MFN 06-261

Docket No. 52-010

Subject: **Response to Portion of NRC Request for Additional Information
Letter No. 44 Related to ESBWR Design Certification Application –
Reactivity Control System – RAI Numbers 4.6-24 through 4.6-26,
4.6-29 through 4.6-33, 4.6-35 through 4.6-37**

Enclosure 1

Typical Core Plate to Shroud Connection

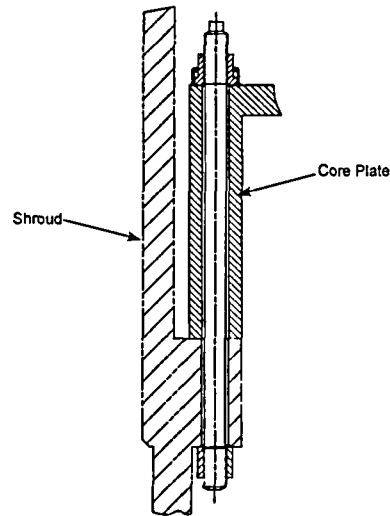
With regard to blowout support, DCD Tier 2, Section 4.6.1.2.2 states, "...after the interconnected assembly of the housing, CRD and [control rod guide tube] CRGT moves down a short distance, the flange at the top of the CRGT contacts the core plate, stopping further movement of the assembly." Whereas, DCD Tier 2, Section 4.1.2.1.2 states, "Each guide tube, with its orificed fuel support, bears the weight of four assemblies and is supported on a CRD penetration nozzle in the bottom head of the reactor vessel."

(a) Describe in further detail the support of the fuel assemblies and the core support plate. Include in your response, address thermal expansion and contraction of the reactor vessel and internals.

(b) Describe the design margin between the CRGT flange elevation and core support plate elevation. In your response, address (1) thermal expansion and contraction of the reactor vessel and (2) differential growth between the reactor vessel and CRGT.

There is no contradiction between DCD Tier 2 Subsections 4.6.1.2.2 and 4.1.2.1.2. Subsection 4.1.2.1.2 describes the reactor configuration in its normal state. In this condition the weld between the CRD housing and the CRD penetration nozzle in the reactor bottom head carries the full weight of the four fuel assemblies, the orificed fuel support, the control rod guide tube and the FMCRD. There is a small gap between the flange at the top of the control rod guide tube and the top of the core plate in this normal state. Subsection 4.6.1.2.2 describes the rod ejection condition in which the weld between the CRD housing and CRD penetration nozzle fails completely. In this case the control rod guide tube drops down a distance equal to the normal gap until its flange at the top engages with the core plate. The core plate then supports the full weight of the four fuel assemblies, the orificed fuel support, the control rod guide tube and the FMCRD and thereby prevents a rod ejection. The core plate is supported by a flange on the inside diameter of the shroud. Shroud support brackets attached to the vessel bottom head in turn support the shroud.

(a) In addition to the description of the support of the fuel assemblies given in DCD Tier 2, Sections 4.1.2.1.2 and 4.6.1.2.2, further descriptions of the fuel supports and the core plate are given in Section 3.9.5.1. Schematic illustrations of the fuel support pieces are shown in Figure 3.9-4. The core plate that provides lateral support of the fuel is bolted to a ledge at the inside lower portion of the shroud as shown in the figure below.

The width of the gap between the flange at the top of the CRGT and the core plate as shown in DCD Tier 2, Figure 4.6-7 is determined to ensure that there will be no interference between the two components during any loading condition of the reactor. In calculating the required gap, the differential thermal expansion between the low alloy reactor vessel and the austenitic stainless steel shroud, core plate and CRGT are considered. Also, included in the calculation are the dilation of the vessel due to internal

pressure and the upward movement of the core plate due to the differential pressure across the core plate.

(b) The size of the gap between the CRGT flange and core plate will be determined upon completion of the detailed design of the reactor vessel and the core support structure. A margin comparable to that of earlier BWRs will be added to the calculated value to ensure that there will be no interference during any loading condition of the reactor.
